**CITY OF TWIN OAKS  
PLANNING AND ZONING COMMISSION MEETING  
VIRTUAL MEETING  
WEDNESDAY, JANUARY 27, 2021 6:30 P.M.**

Site Development Plan for  
**ALDI, INC.**  
1100 MERAMEC STATION ROAD  
TWIN OAKS, MISSOURI 63021

I obtained from you on December 2, 2020, the Aldi Plan Sheets (4 pages) for the 1100 Meramec Station Road proposed development in commercial district "C". The information was reviewed to evaluate compliance with the Code of Ordinance for Twin Oaks.

Concept Sightline

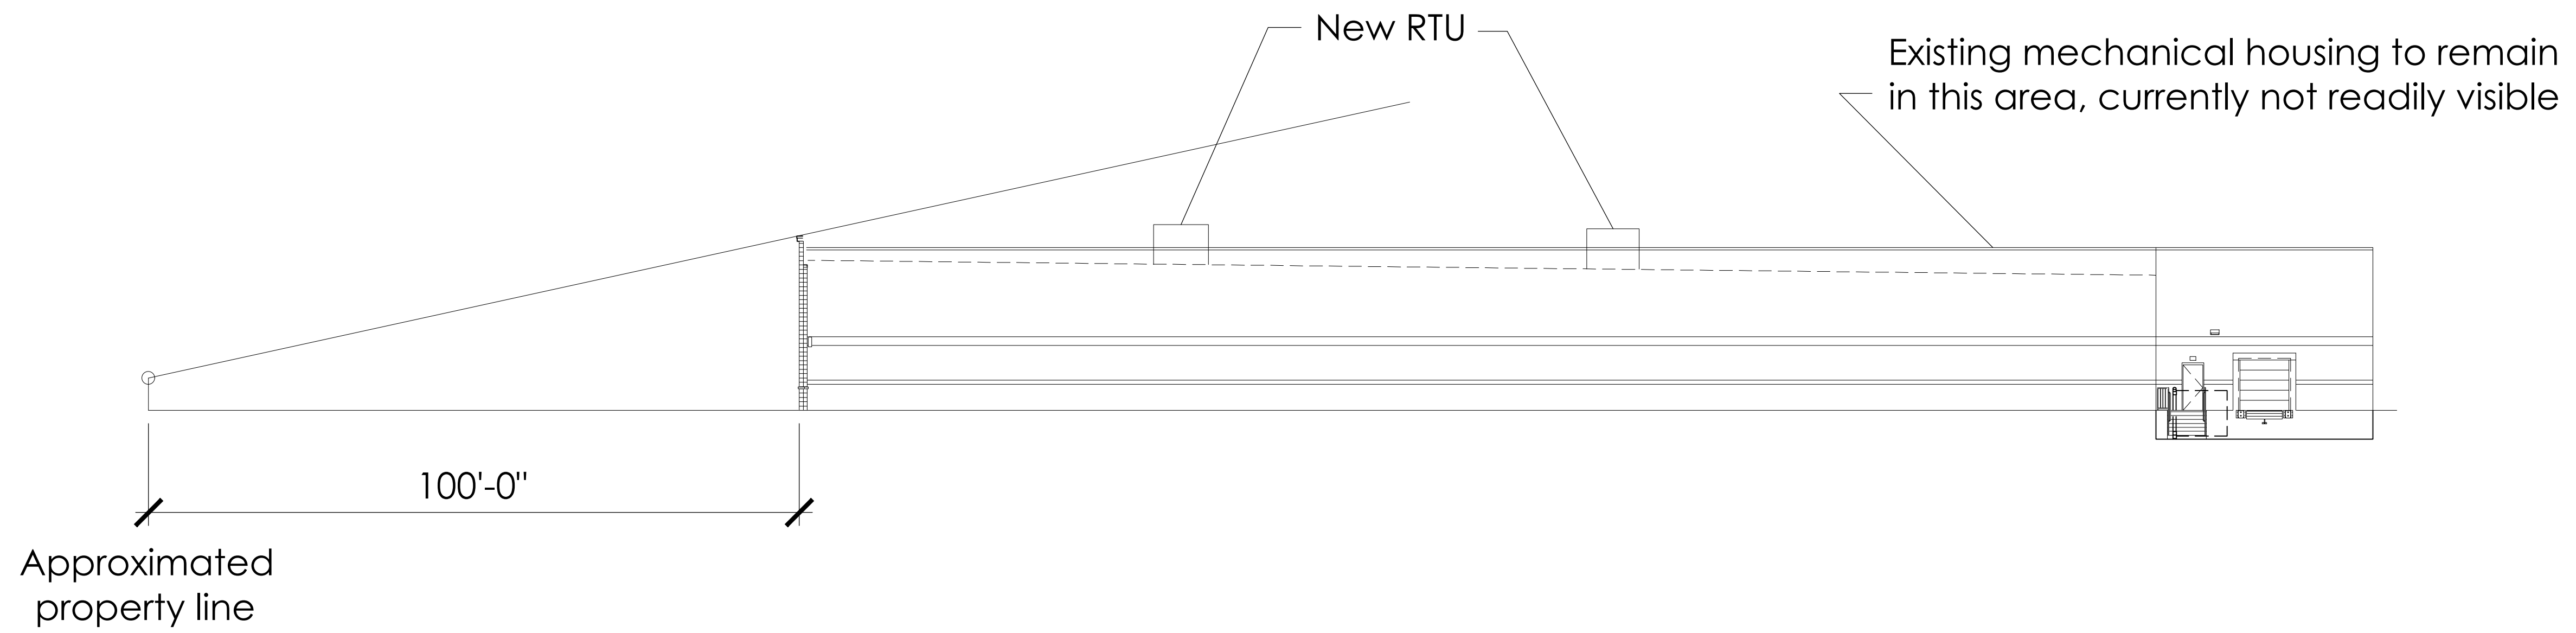
**Paragraph 3 comment 2:** Please provide a plan that displays the proposed rooftop equipment. Ensure proposed rooftop equipment is adequately screened per Section 400.330.A.6.

**Response:** Please see **enclosed sightline study** which shows the rooftop equipment should not be readily visible from the property lines.

**2<sup>nd</sup> Review: This comment is addressed.**
2. Please provide a plan that displays the proposed rooftop equipment. Ensure proposed rooftop equipment is adequately screened per Section 400.330 A.6.

1 Concept Floor Plan  
SCALE: 1/8" = 1'-0"

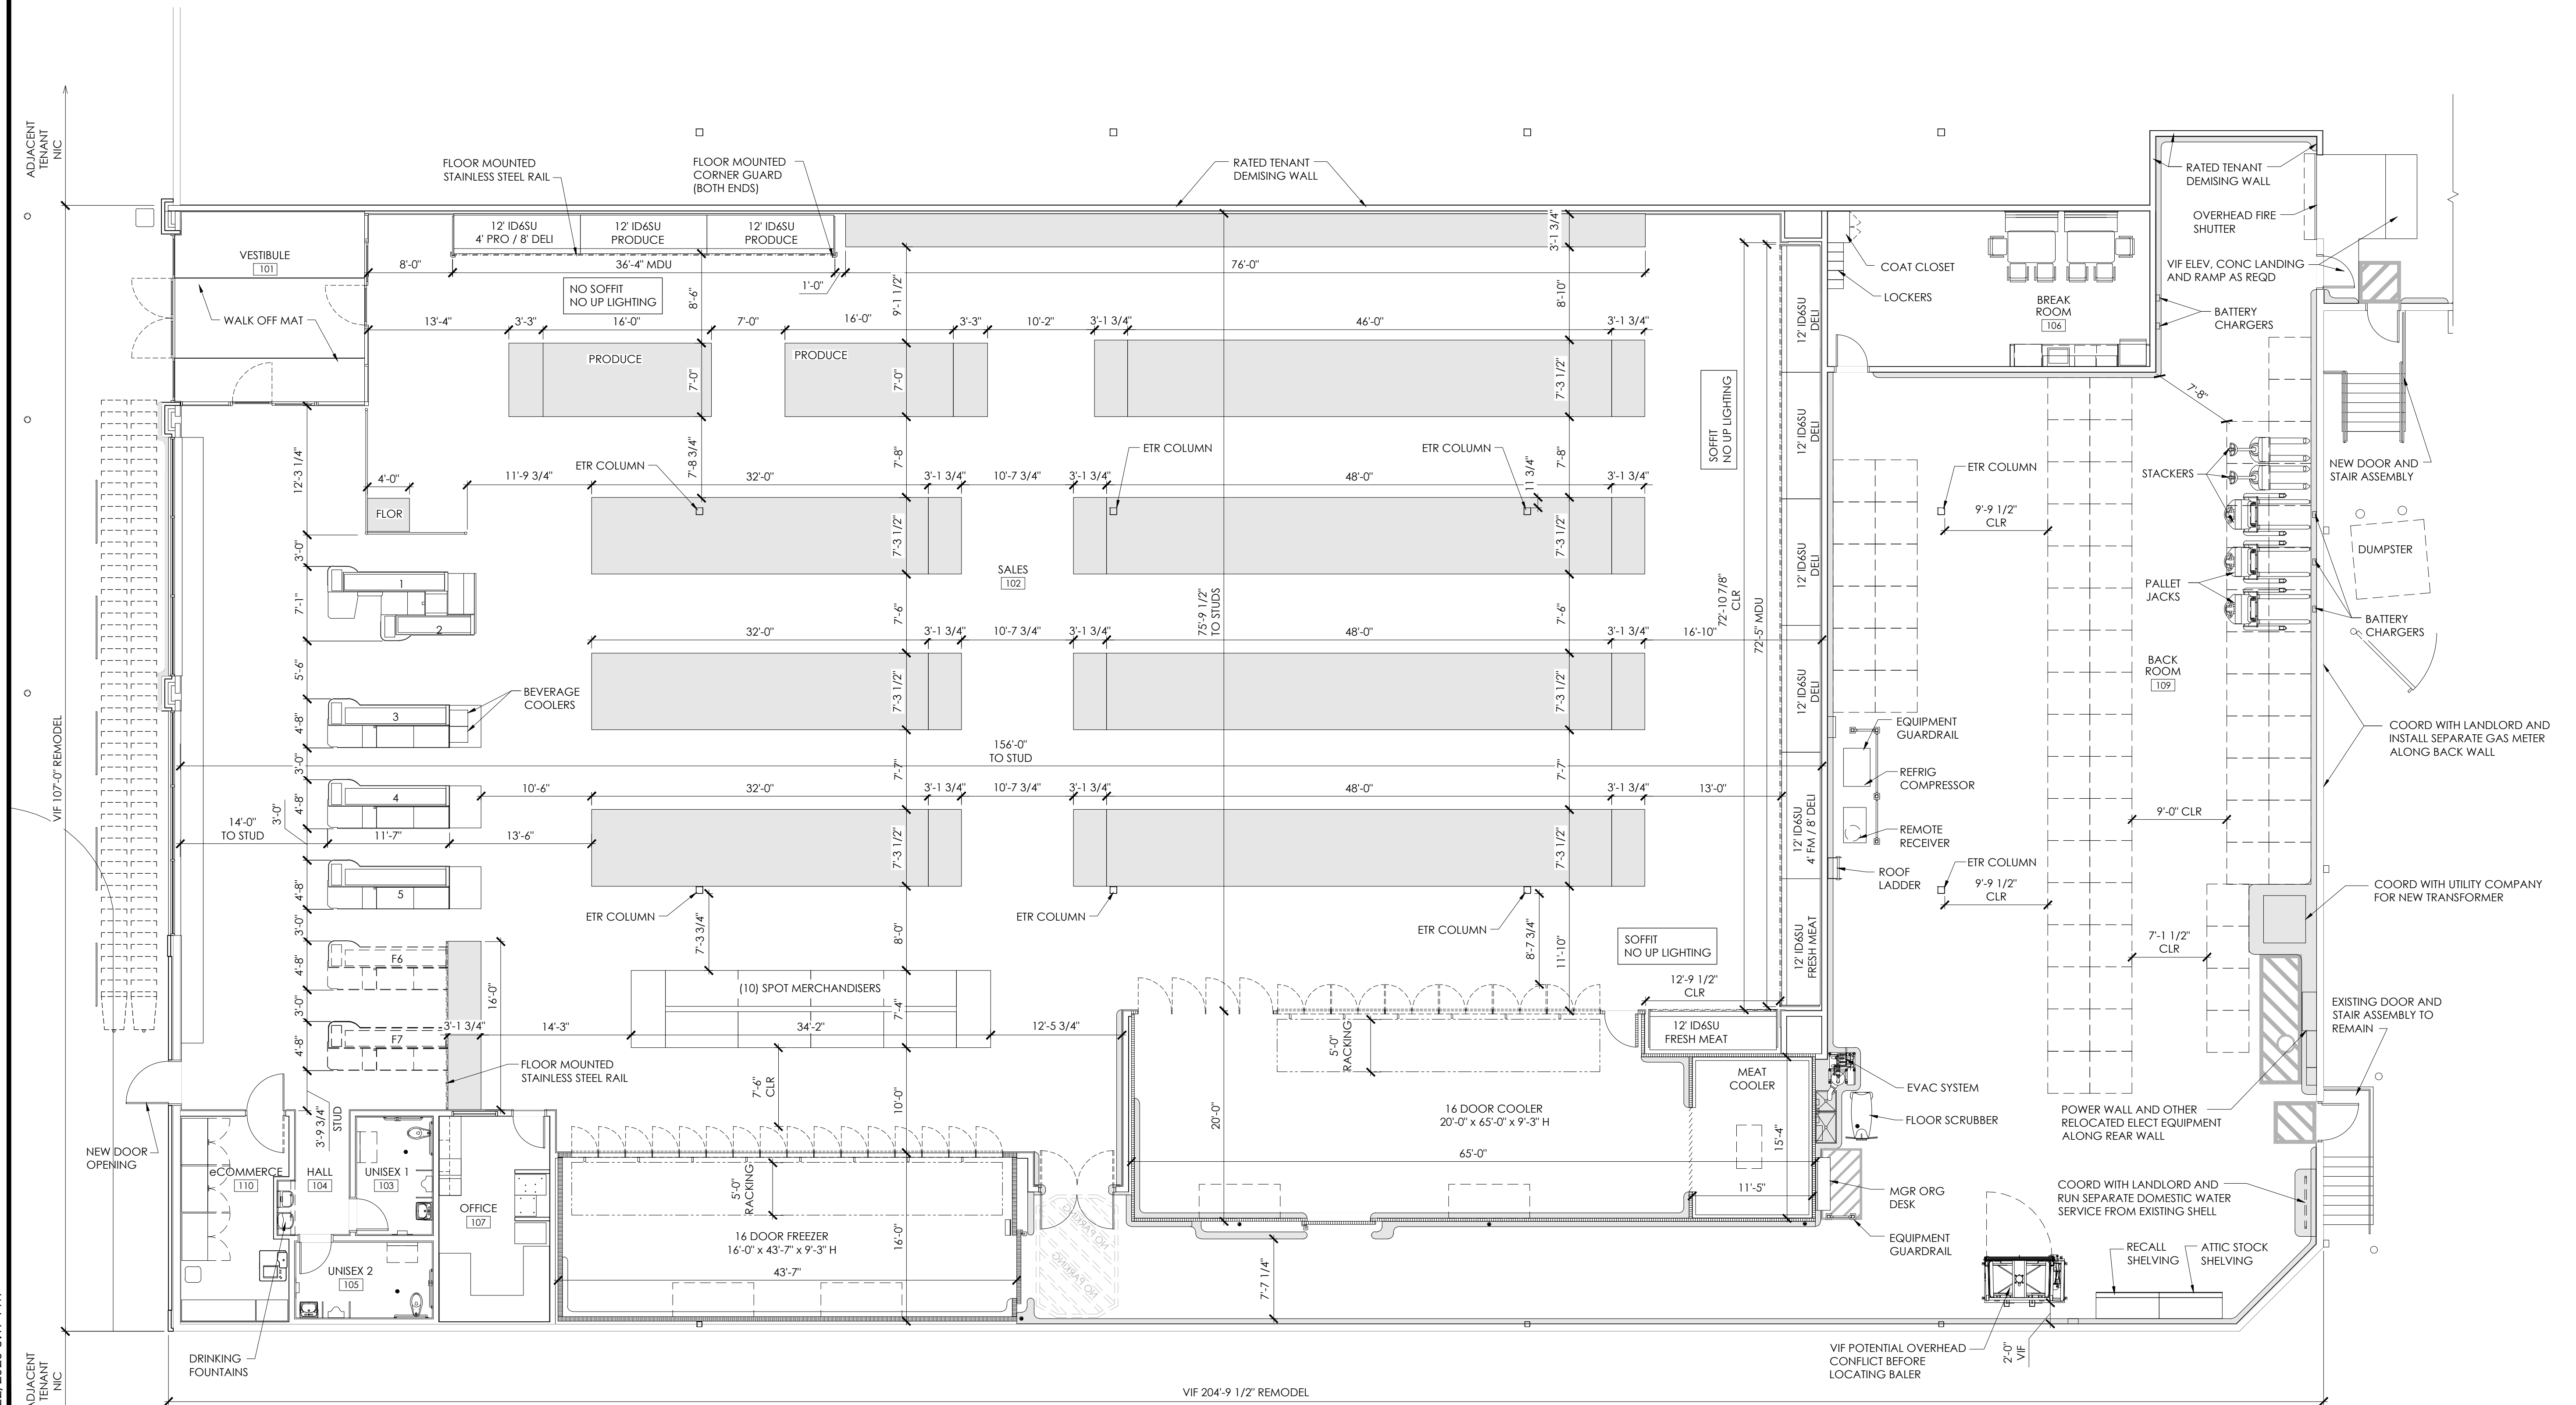
**Paragraph 1 comment 6:** The current design does not provide screening to the proposed trash container. Please reevaluate the design and screen trash container with evergreen hedges, walls, screens planted with evergreen vines per Appendix A F.4.

**Response:** The view from La Bonne Pkwy on the east is almost completely screened due to the existing retaining wall with fence, as well as a significant drop in grade elevations. The view from the neighboring business on the south is on the same boat, but a screen door is added. Please see **enclosed CFP-1 and CEE-1**.
